LIST OF STANDARD DRAWINGS APPLICABLE FOR 245kV IVT

CUSTOMER : APTRANSCO				TITLE : LIST OF STANDARD DRGS. / DOCUMENTS APPLICABLE FOR 245 kV IVT (CREEPAGE = 25 mm/ kV)	
4				GEN. TOL.	MATL.: SPEC.:
3				THIRD ANGLE PROJECTION	
				SCALE: NTS	INITIALS NAME
2				ALL DIMNS. IN MM. UNLESS OTHERWISE SPECIFIED.	ORG NSB CHD PBN
1				APPD	USS
NO	REVISION	SIGN	DATE	DATE : 15.12.2021	DRG.NO: 3-VAD 3391
					REV 0

GEN. TOL.	MATL.:	TITLE : STANDARD DRAWING GENERAL ARRANGEMENT OF 245 kV IVT (CREEPAGE = 25 mm/ kV)
	SPEC.:	
THIRD ANGLE PROJECTION		
SCALE: NTS	INITIALS	NAME
ALL DIMNS. IN MM. UNLESS OTHERWISE SPECIFIED.	ORG	NSB
	CHD	PBN
	APPD	USS

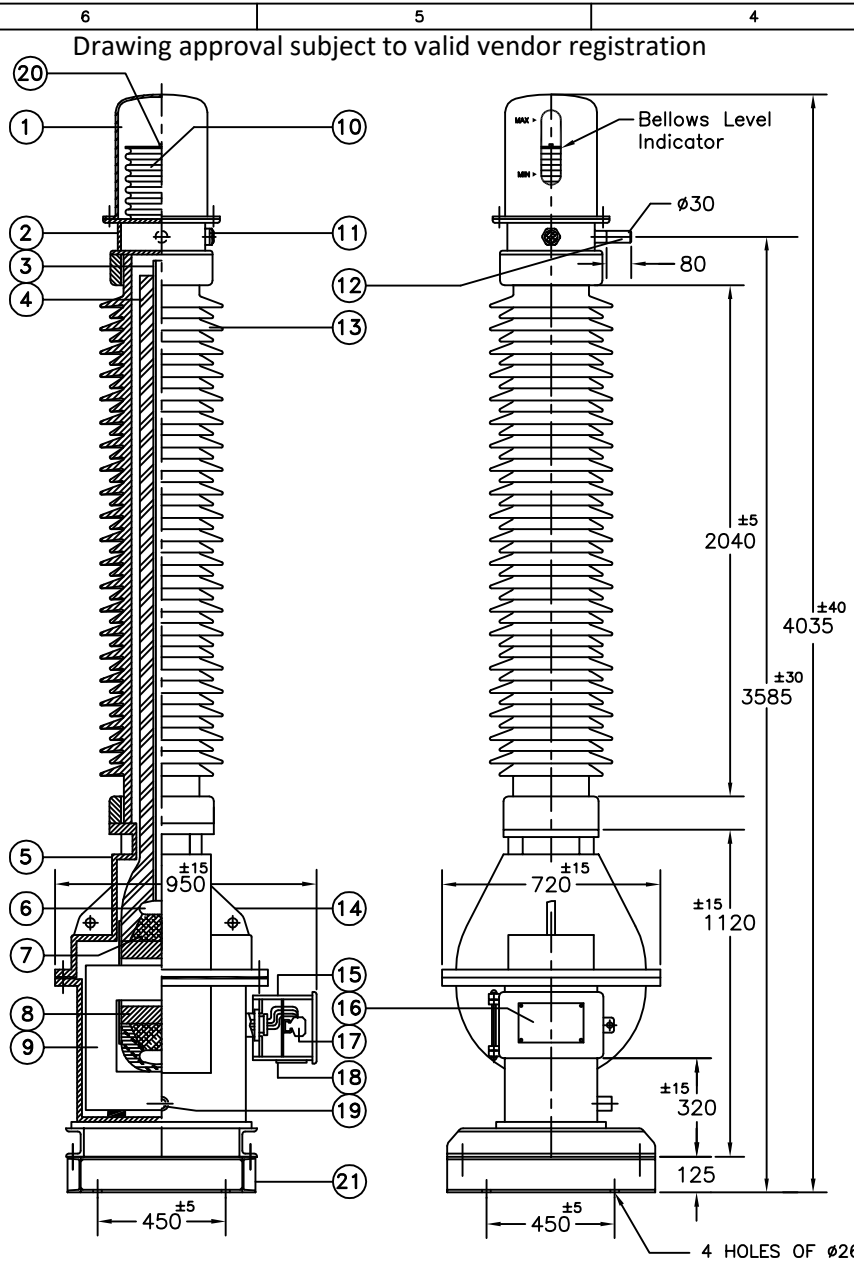
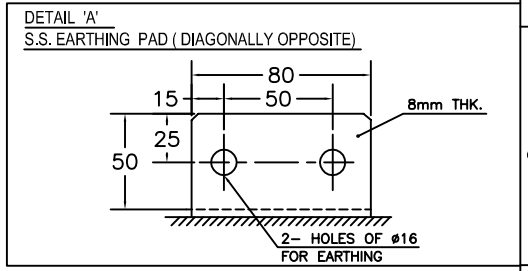
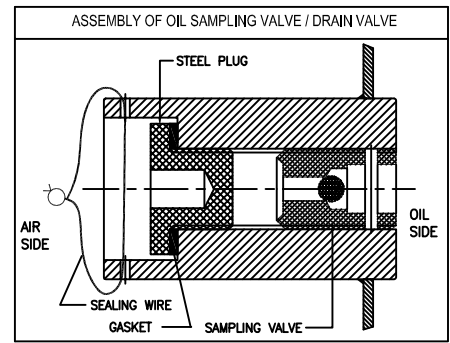
NOTE : DRAWING APPROVAL SUBJECT TO VALID TYPE TEST REPORTS, TO BE CHECKED DURING ACCEPTANCE TESTS.

FOR EPC CONTRACTS ONLY

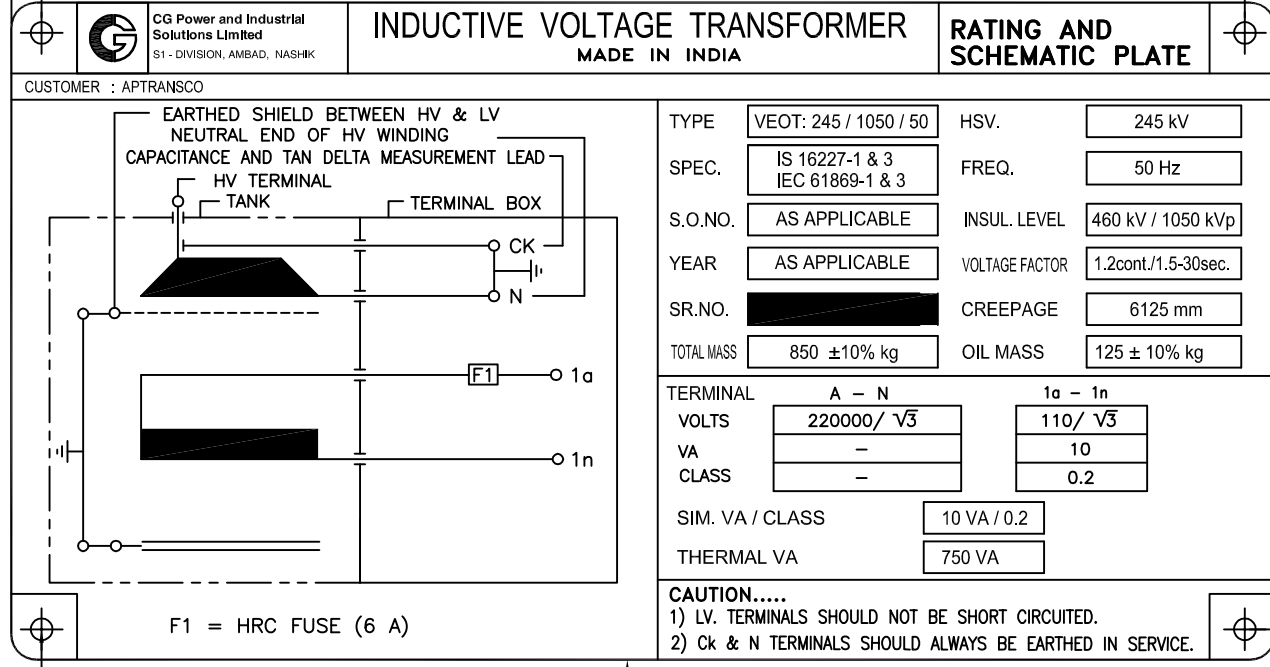
- 1). Minimum 300 mm Plinth shall be maintained for Current transformers in the substation during foundation works to ensure safe live to ground clearances as per IE rules.
- 2). Since the supply of terminal connectors is not in the scope of CT Manufacturer as mentioned in the drawings, the EPC contractors shall be instructed to supply the same in line with the CT requirement and compatibility.

CUSTOMER : APTRANSCO			
GEN. TOL.	MATL. SPEC.:	TITLE : STANDARD DRAWING SECONDARY BOX GA OF 245 kV IVT ( CREEPAGE = 25 mm/ kV )	
THIRD ANGLE PROJECTION			
SCALE: NTS	INITIALS	NAME	
ALL DIMNS. IN MM. UNLESS OTHERWISE SPECIFIED.	ORG	NSB	
	CHD	PBN	
	APPD	USS	
DATE : 15.12.2021			REV 0

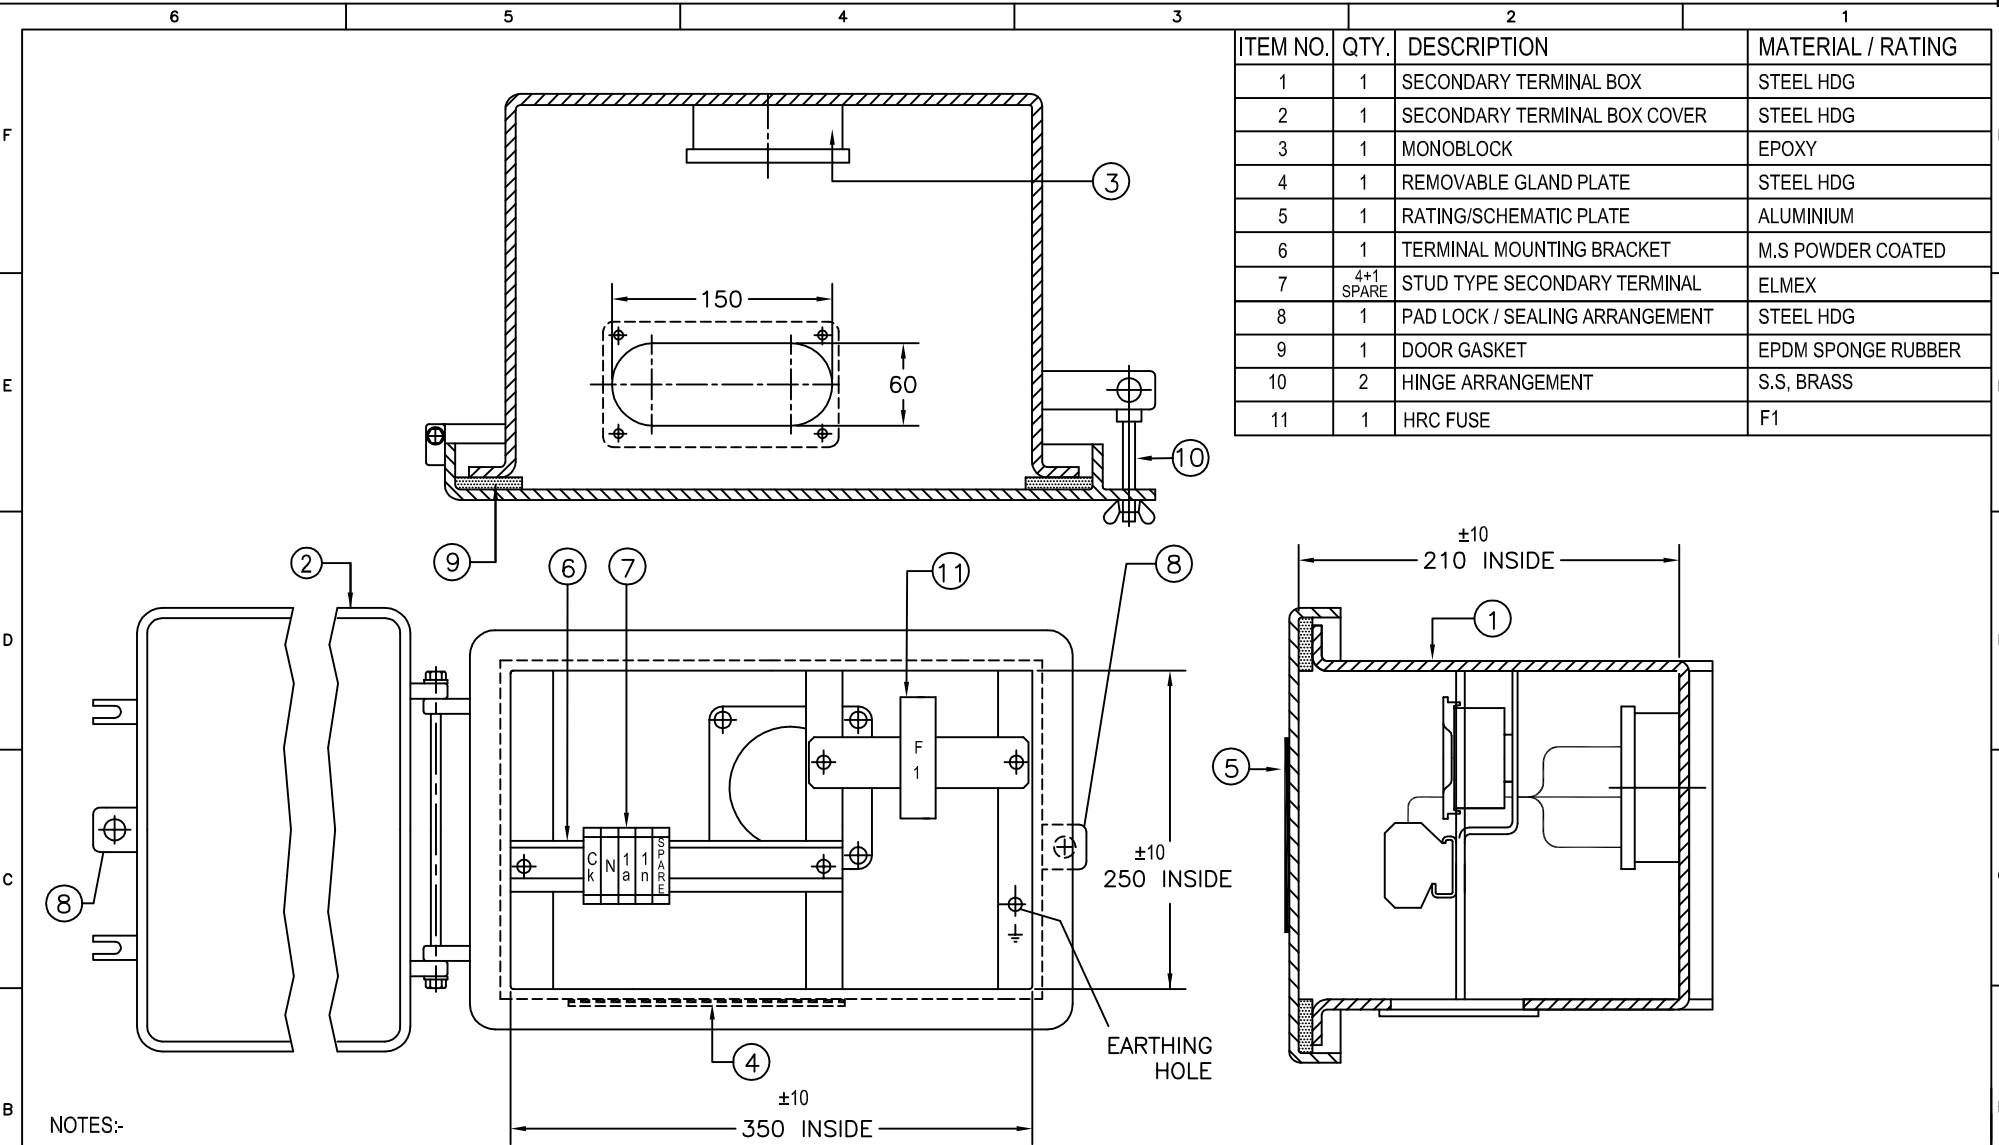
NOTE : DRAWING APPROVAL SUBJECT TO VALID TYPE TEST REPORTS, TO BE CHECKED DURING ACCEPTANCE TESTS.
